TT00001

Cylinder Head Installation For 2003-2005 Ford 6.0L Diesel Engines

S. B. International, Inc., offers the following information regarding cylinder head installation for 2003-2005 Ford 6.0L diesel engines. This bulletin is being revised to reflect changes to the head bolt torque sequence originally published.

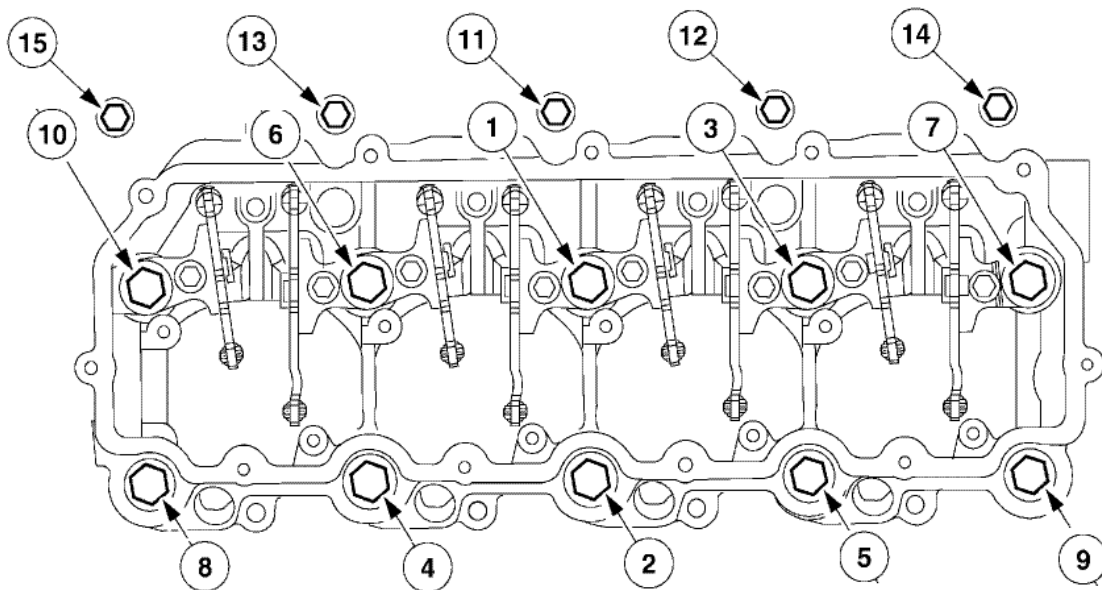
NOTE: To prevent engine damage, you must always REPLACE all M14 x 192 cylinder head bolts when installing the cylinder head. Lightly lubricate M14 x 192 bolt threads and mating surfaces of bolt flanges with clean engine oil. Too much oil will cause hydrostatic lock and give incorrect torque reading. Do not lubricate the M8 x 70 bolts. Do not use anti-seize compounds, grease, or any other lubricant except engine oil. Other lubricants have an adverse effect on torque results. Follow the steps listed below to correctly install this engine's cylinder heads. Refer to Figure 1 below for the proper sequences.

M14 Bolts

1. Torque lubricated bolts in the sequence numbered 1 through 10 to 65 ft/lbs (88Nm).
2. Torque all bolts in sequence numbered 1 through 10 to 85 ft/lbs (116 Nm).
3. Torque all bolts in sequence numbered 1 through 10, clockwise 90°.
4. Torque all bolts in sequence numbered 1 through 10, a second time clockwise 90°.
5. Torque all bolts in sequence numbered 1 through 10, a third time clockwise 90°.

M8 Bolts - DO NOT LUBRICATE M8 BOLTS
